SEPTEMBER 16, 2022

ADDENDUM NO. 02 to the plans and specifications for the MACOMB COUNTY JAIL, VARIOUS PROJECTS PROPOSAL A, B AND C, MT. CLEMENS, MI, Architect's Project No. 221958, dated August 26, 2022

**PROPOSAL A-SANITARY REPLACEMENT**

**PROPOSAL B-BARRIER MESH/SCREEN**

1. ALL WORK SHALL COMPLY WITH NATIONAL, STATE AND LOCAL CODES, ORDINANCES AND REGULATIONS.
2. ALL MATERIALS SHALL BE INSTALLED/APPLIED IN STRICT ACCORDANCE WITH MANUFACTURER'S REGULATIONS.

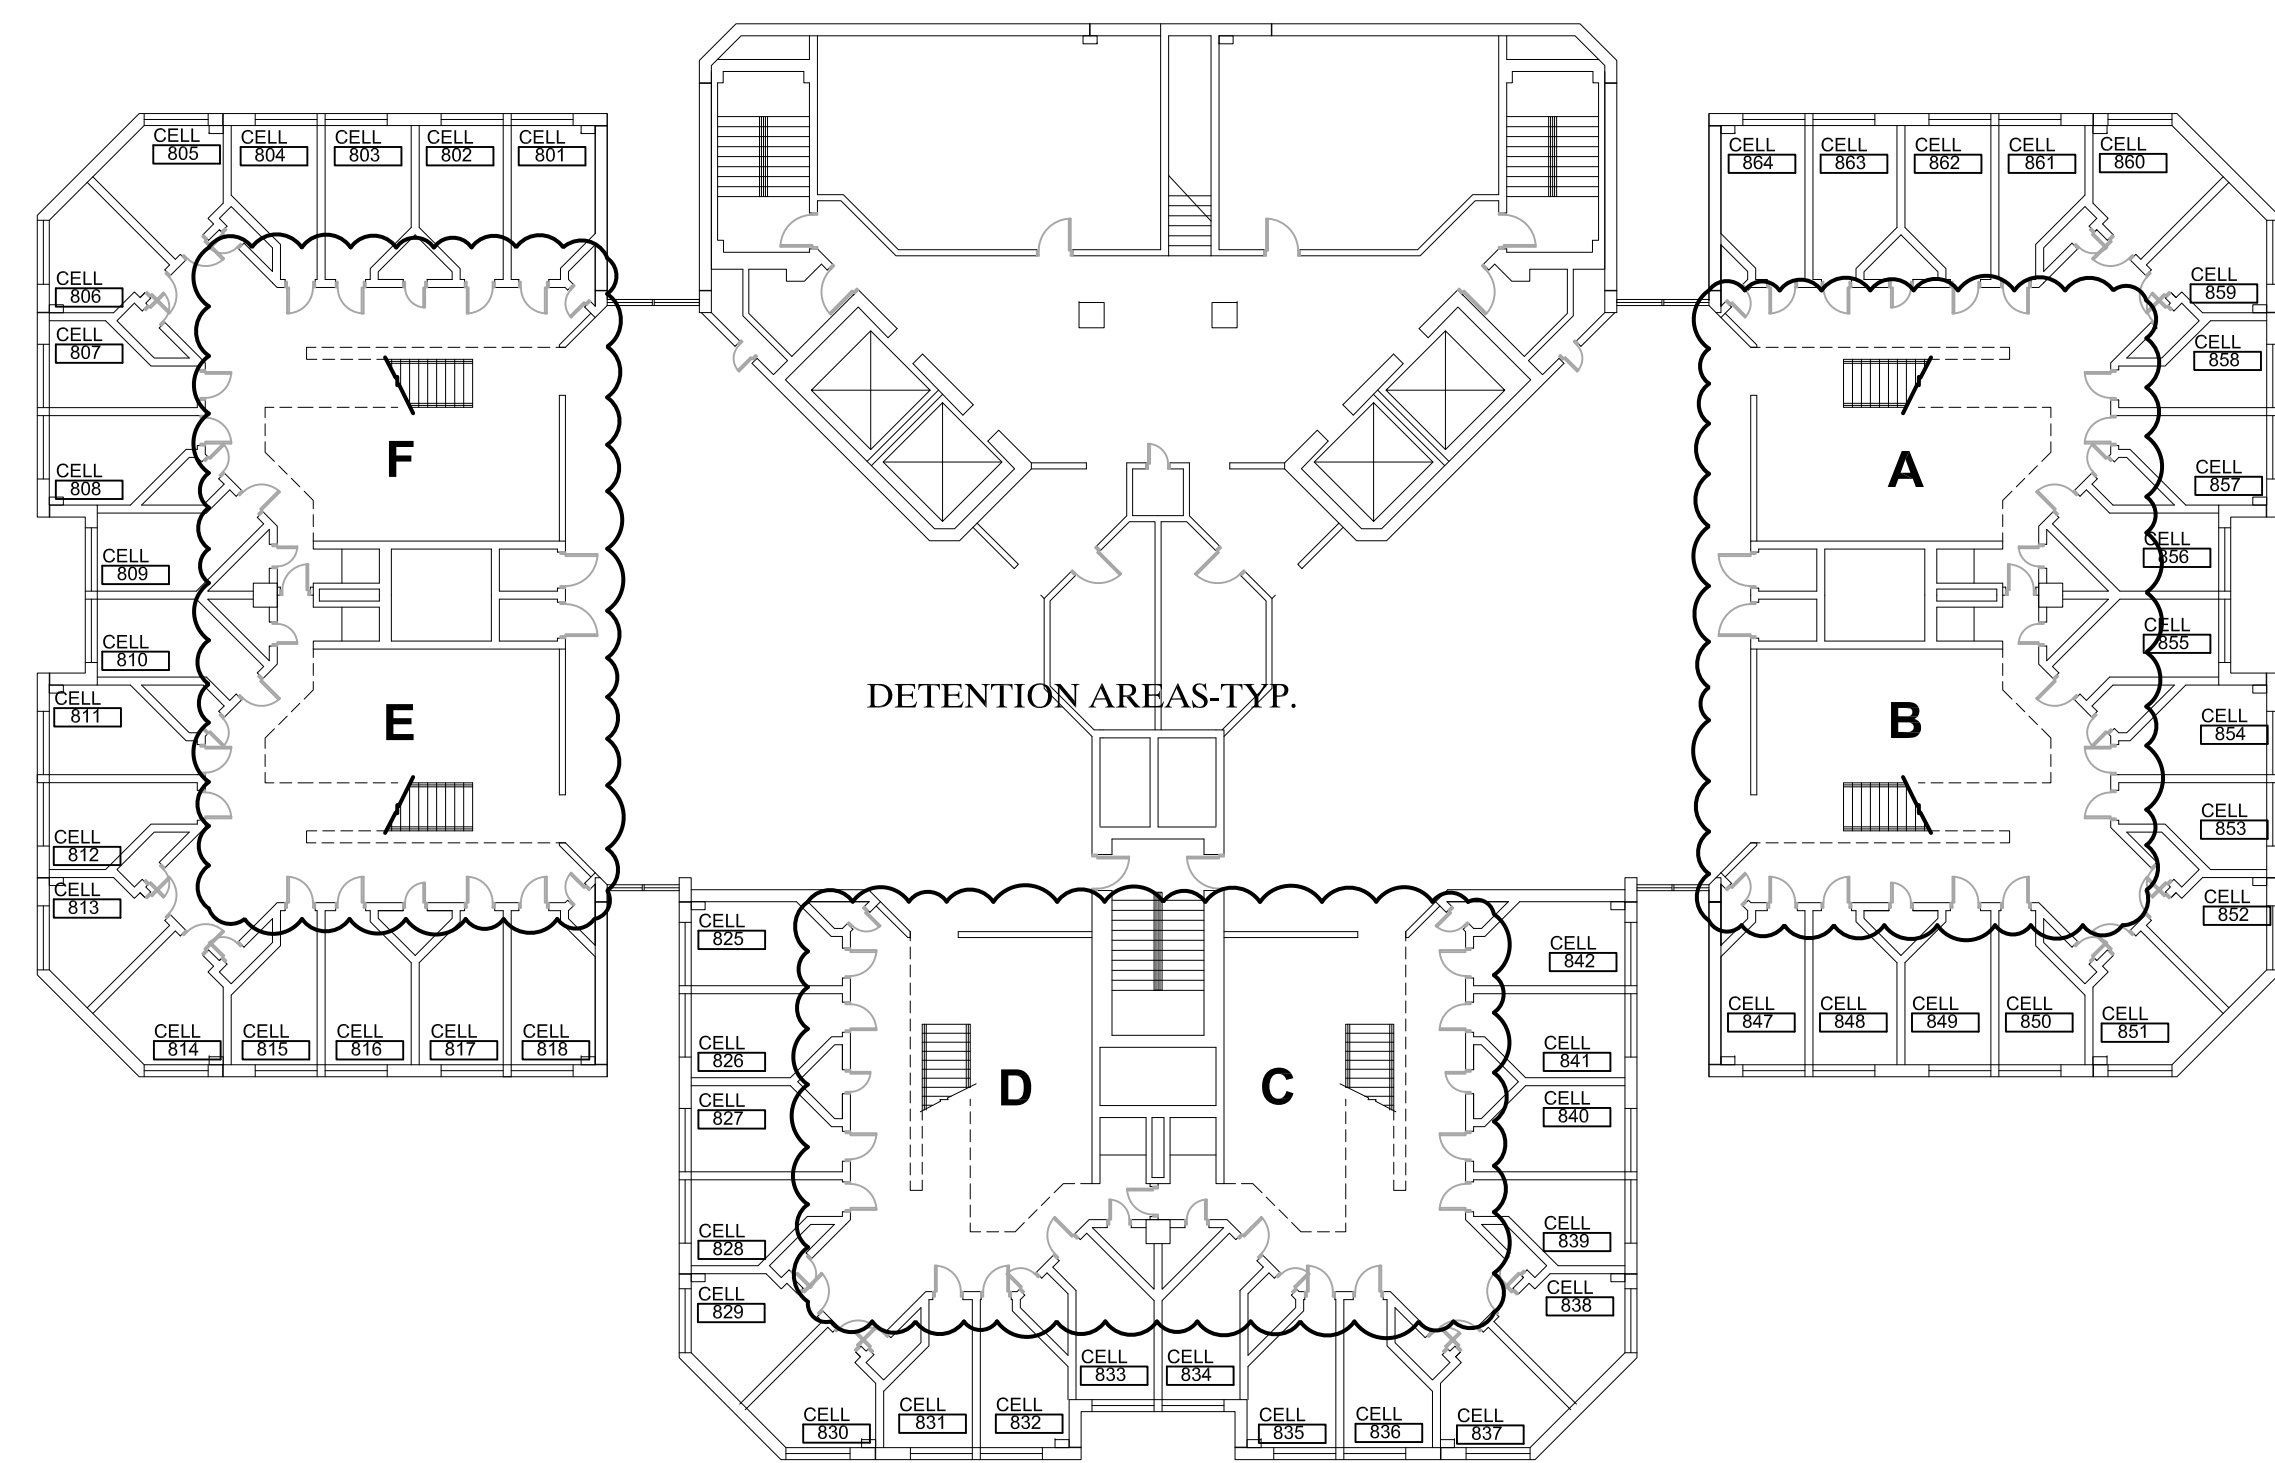
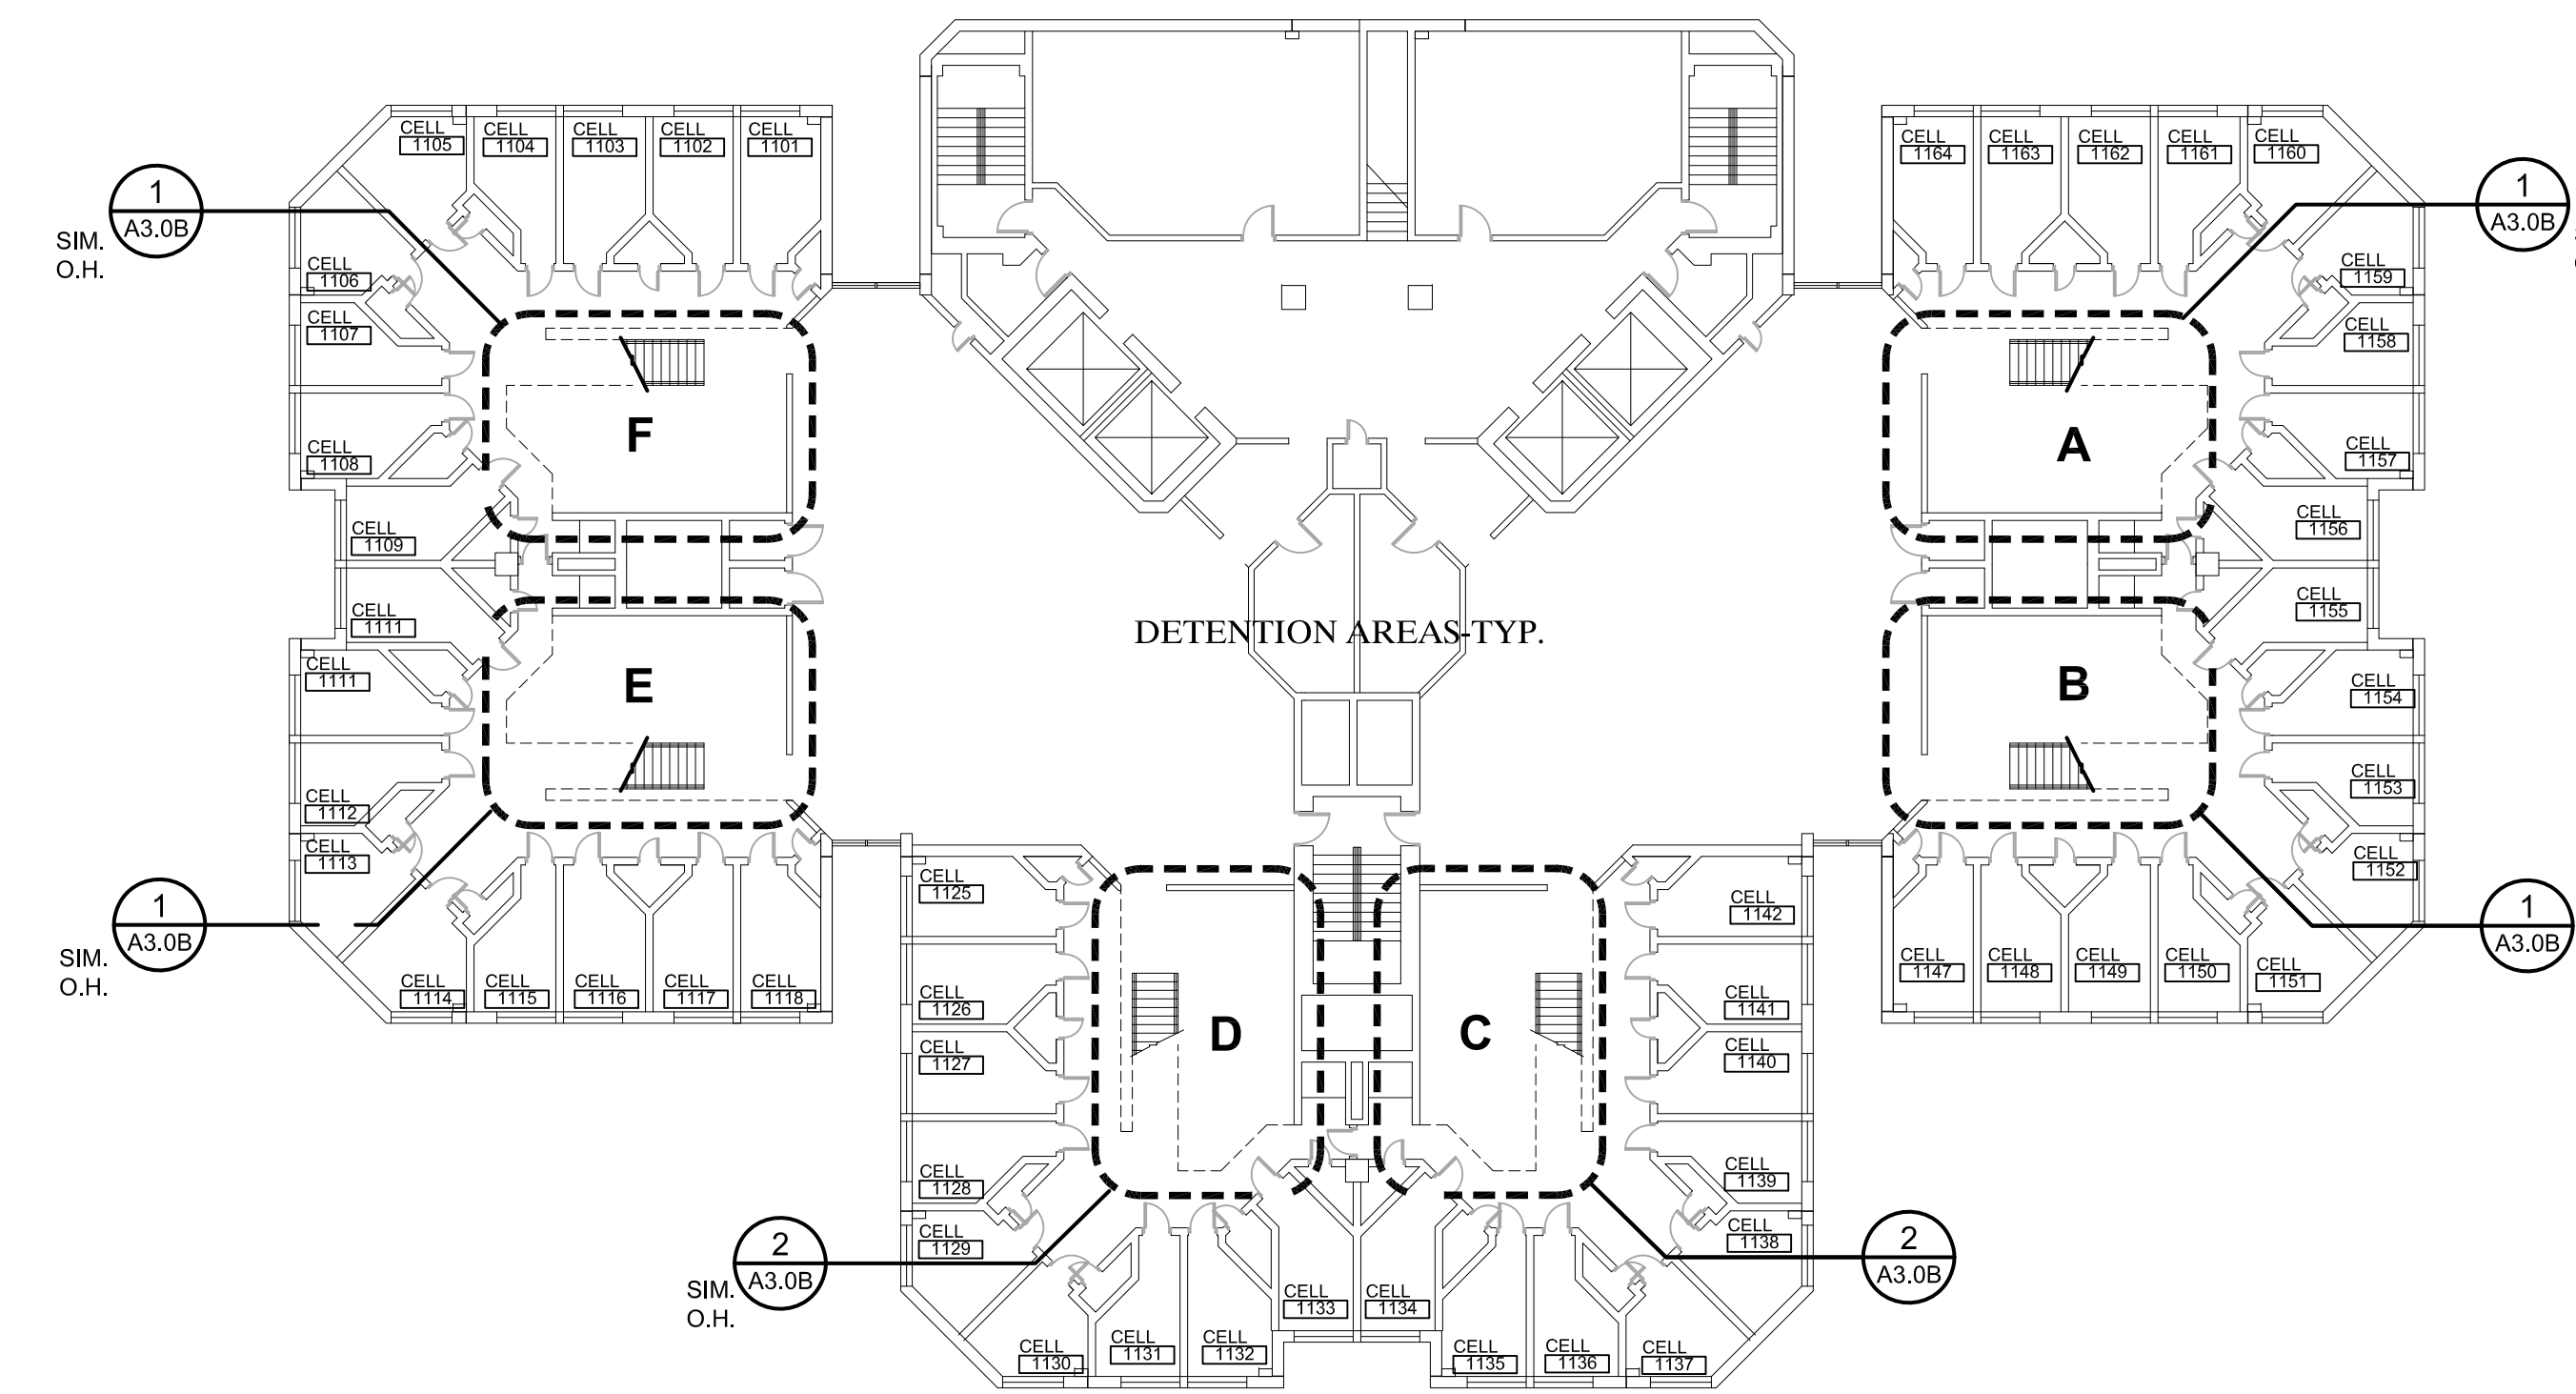
- ITEM NO. A4:** Refer to sheet A0.4A (re-issued):
1. Removed callouts 1 and 2 from the floors 8 and 10.
